Access Compliance Report Public Rights-of-Way (Curb Ramps)

Main Street: RAMM_DR Cross Street: THISTLE_RD Location: N

ADA ID: RPAT211130134552 Ramp Type: Type 6 - Directional 1 Initial Pass/Fail: Fail Overall Compliance: No Severity Score: 2

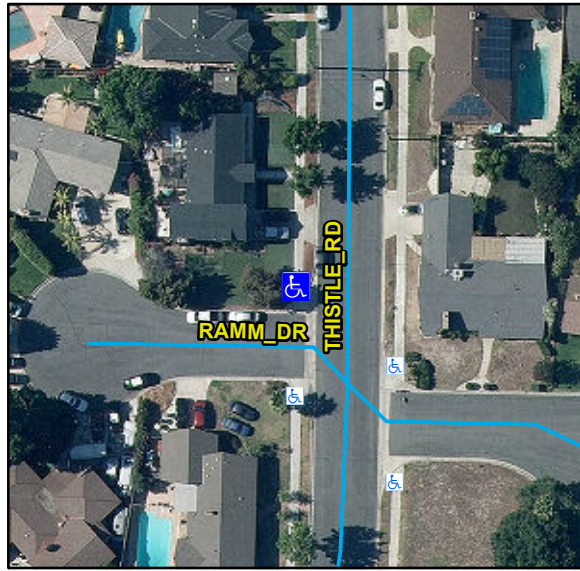
Compliance	Description	Data	Compliance	Description	Data
N/A	Ramp Length (in)	122	N/A	Flare Type LT	
Yes	Ramp Width (in)	60			N/A
Yes	Ramp Run Slope (%)	6.9	N/A	Flare Slope LT (%)	N/A
Yes	Ramp Cross Slope (%)	0.8	N/A	Flare Traversable LT	N/A
N/A	Grade Break	N/A	N/A	Flare Type RT	
N/A	Grade Break Slope (%)	N/A			N/A
N/A	Grade Break Cross Slope (%)	N/A	N/A	Flare Slope RT (%)	N/A
	Addl Para Ramp Left?	No	N/A	Flare Traversable RT	N/A
	Addl Para Ramp Right?	No	N/A	DWS Provided	N/A
N/A	Landing Present	N/A	N/A	DWS Contrast	N/A
N/A	Landing Length (in)	N/A	N/A	DWS Length (in)	N/A
N/A	Landing Width (in)	N/A	N/A	DWS Full Width	N/A
N/A	Landing Run Slope (%)	N/A		DWS Offset Type	N/A
N/A	Landing Cross Slope (%)	N/A	N/A	DWS Left Offset (in)	N/A
N/A	Landing Movement Obstructed?	N/A	N/A	DWS Right Offset (in)	N/A
	Landing Movement Type	N/A			
N/A	Landing Shared	N/A			
N/A	Marked Crosswalk 1	No	N/A	Clear Space	N/A
	Crossing 1 Direction	S	N/A	Clear Space To Crosswalk (in)	N/A

Marked Crosswalk 1 Width (in)	N/A			
N/A	Ramp Inside Crosswalk 1	N/A			
	Crossing 1 Slope (%)	2.6			
	Crossing 1 Cross Slope (%)	0.5			
N/A	Gutter Ponding	N/A	Yes	Curb Slope	4.5
Yes	Gutter Lip Height (in)	0		Road Run Slope (%)	N/A
N/A	Gutter Run Slope (%)	N/A		Road Cross Slope (%)	N/A
N/A	Gutter Cross Slope (%)	N/A		Parallel Ramp Side	N/A
Yes	Overall Surface Condition	Acceptable	Yes	Perp Joint Present	Yes
	Cross Gutter Present?	Yes		Spandrel Present?	Yes
	Replace Cross Gutter?	No		Replace Spandrel?	No

Remove & Replace Entire Ramp.
